Addendum #1 - Bid Package #6929-06

Project Name: Lincoln Public Schools District Office
5901 'O' Street
Lincoln, NE
Project No.: 11065
Issued: June 15, 2012

Sketch A1
Bid Package 6929-06
Addendum 01

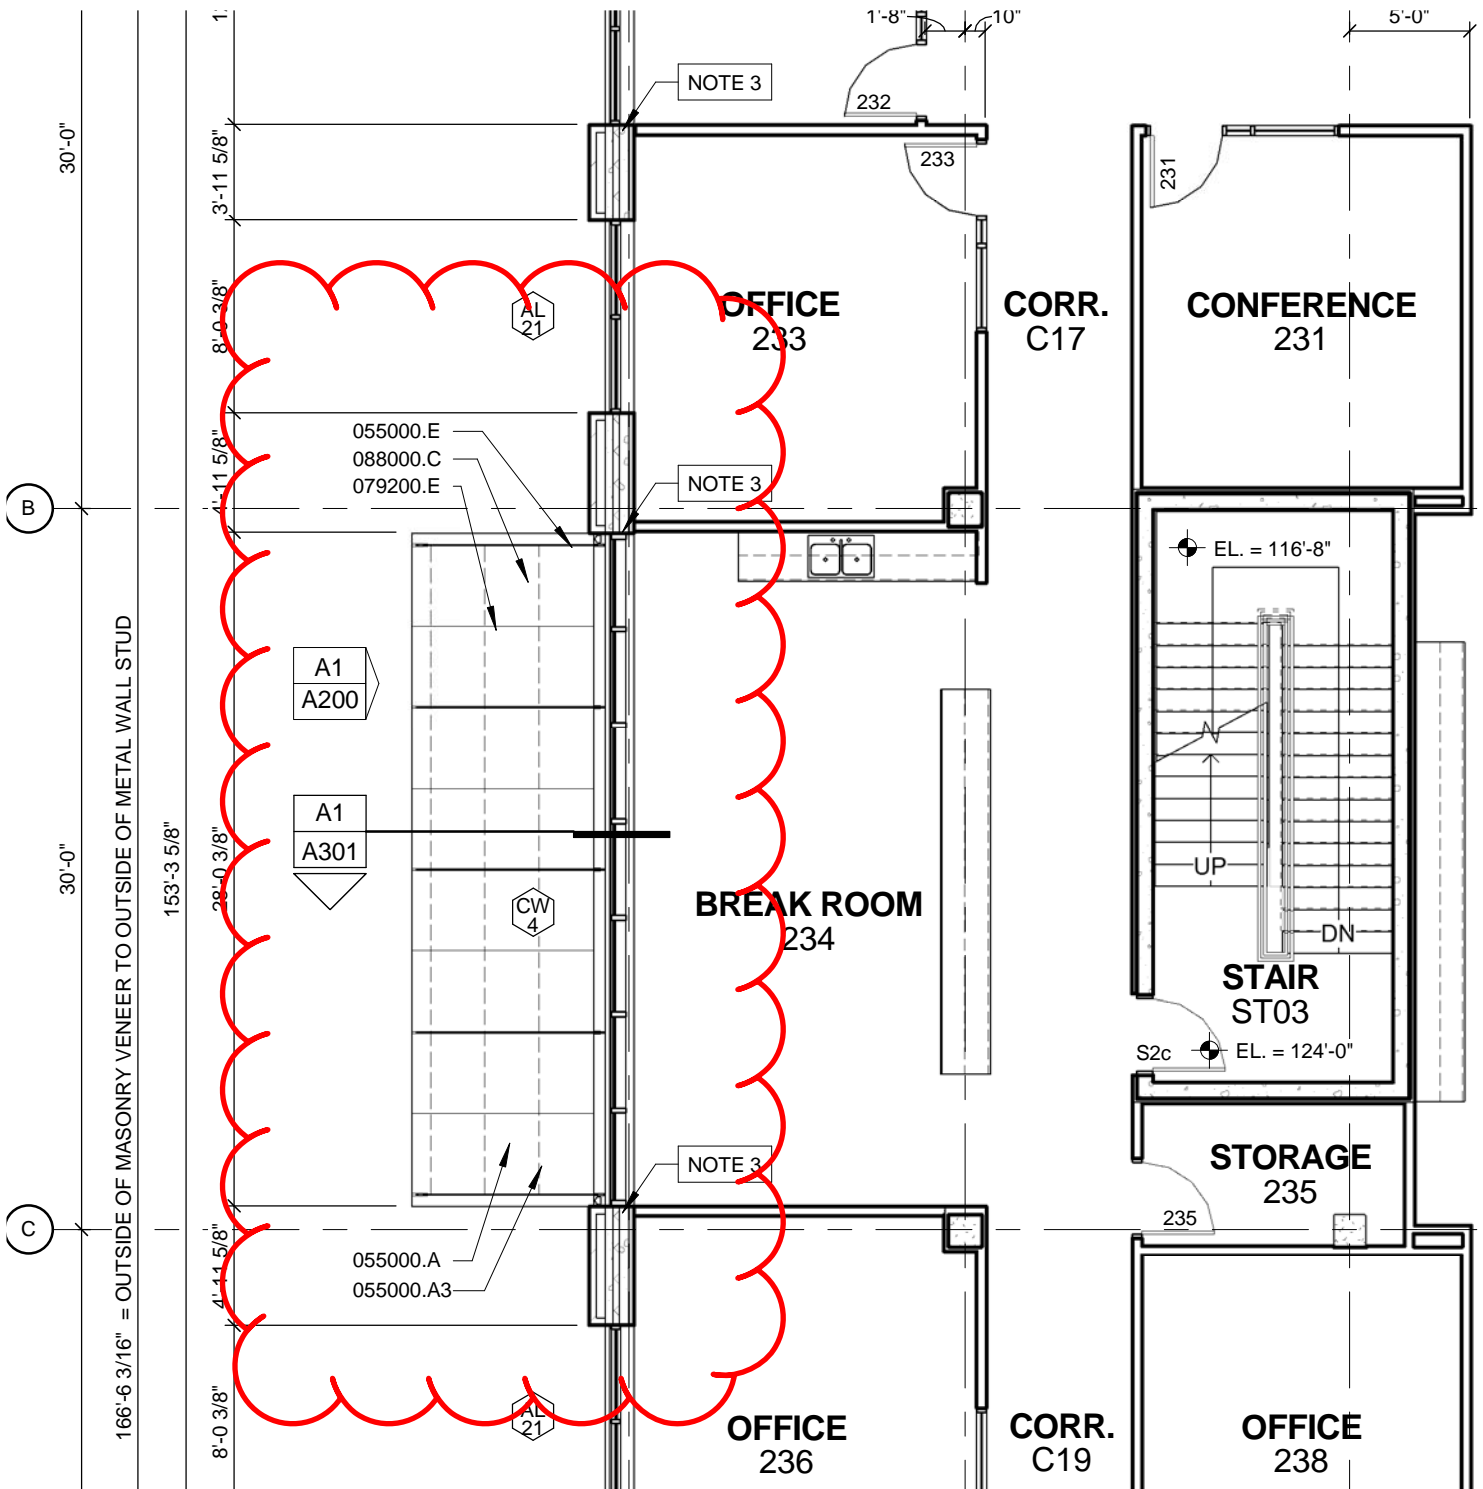
- ADD 1-6.** To better clarify the configuration of framing for the AL24, 25 and 27 frames around the second level conference rooms, we have attached **Sketch A1**. The center area in the AL24 frames is a stud wall with GWB.

Sketch A3
Bid Package 6929-06
Addendum 01

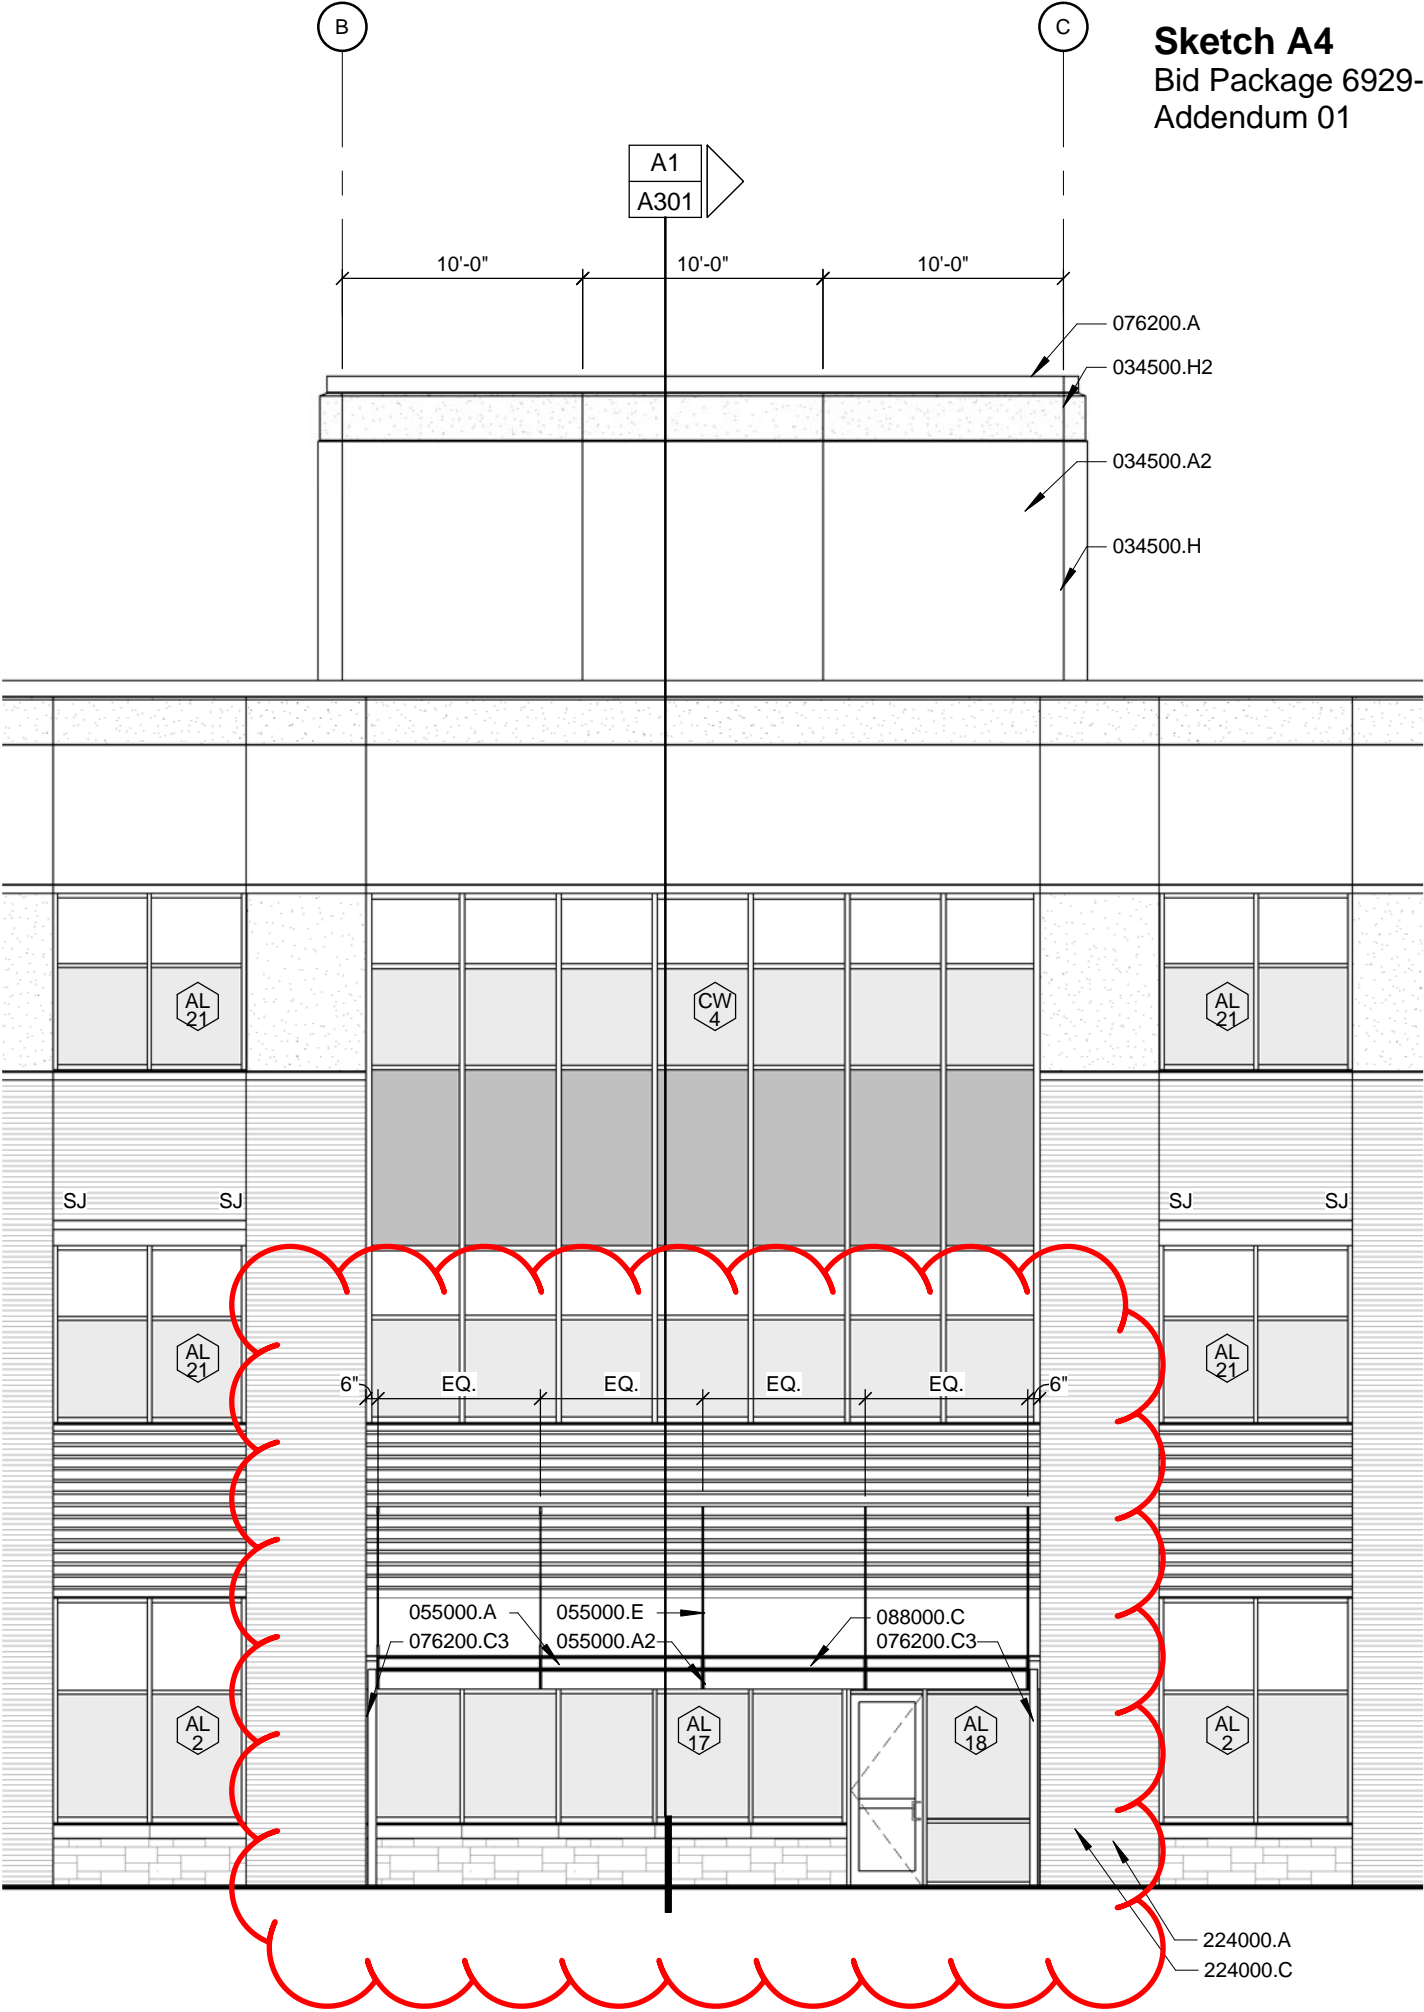
- ADD 1-20.** Refer to Sheet A102, Detail A1; Between Grids 6 and 9 on Grid A, note the addition of the roof plan for the canopies located at Ground Level below along with the associated keynotes. Refer to attached **Sketch A3**.

Sketch A4
Bid Package 6929-06
Addendum 01

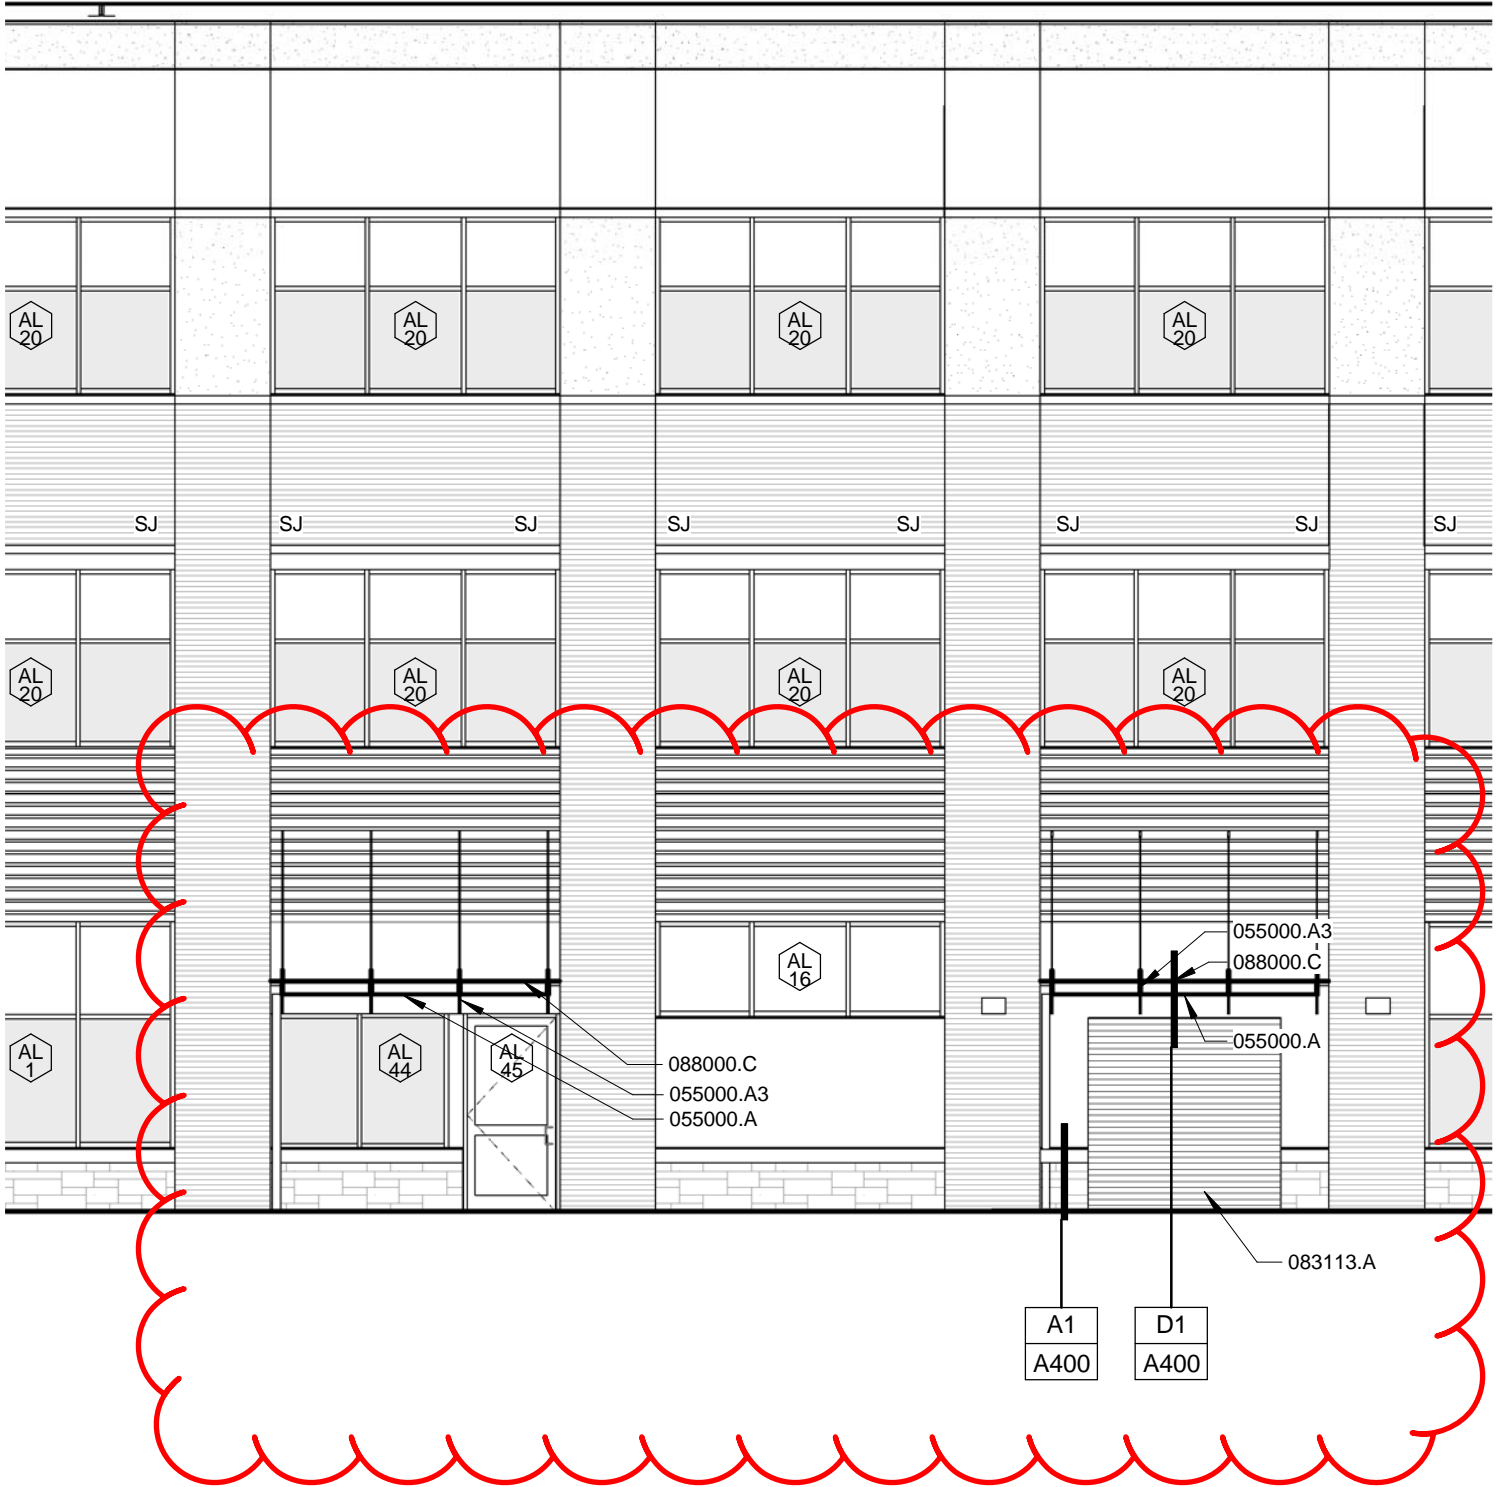
- ADD 1-21.** Refer to Sheet A200, Detail A1; Between Grids B and C, above the Ground Level windows note the modifications to the elevation due to the change in canopy height. Frames AL17 and 18 are modified and canopy has been keynoted. Keynotes have also been added for components of canopy assembly including downspouts. Precast spandrel panel has also increased in height. Refer to attached **Sketch A4**.
